**Douglas Dewey**

**27 March 2020**

**Submission against Draft Voluntary Planning Agreement - 31 Bellara Avenue  
and 66 Powderworks Road, North Narrabeen VPA2020/0001**

#### **9.1.7 D.1.5 Characteristics of Roads in Residential Subdivision Road Networks**

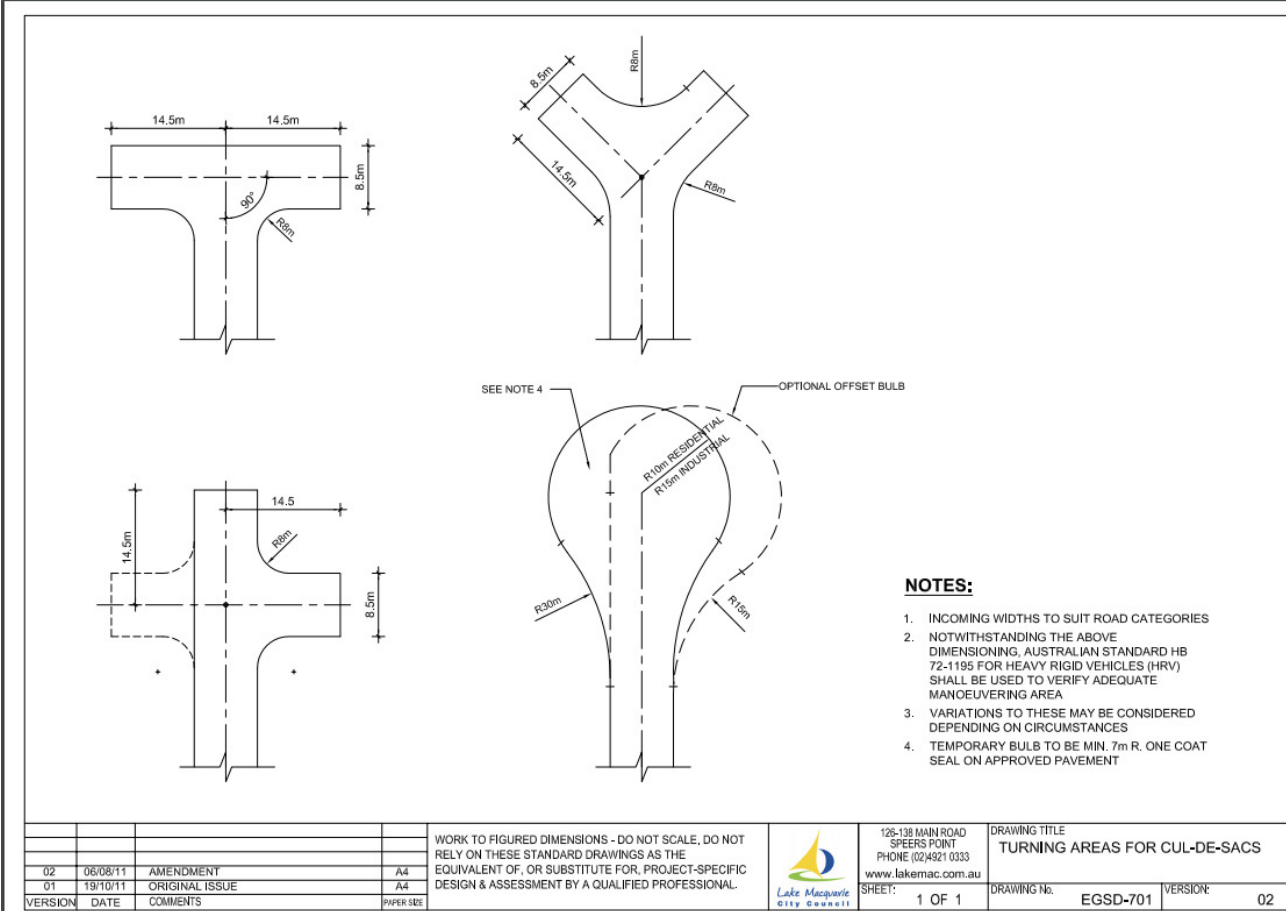
- Table D.1.5 for a local road such as Bellara Ave requires the following which have not been met in the design of the proposed VPA.
  - Carriageway width 7.8m up to 1,000 vehicle per day. The current carriageway is 7m.
  - Parking Provision Carriageway – the proposed design will require no-standing in the entire area which result in the loss of at least 3 on-street parking lots.
  - Footpath requirement 1.82 wide (VPA no footpath)
  - Verge width 4.0m minimum. (VPA non verge)
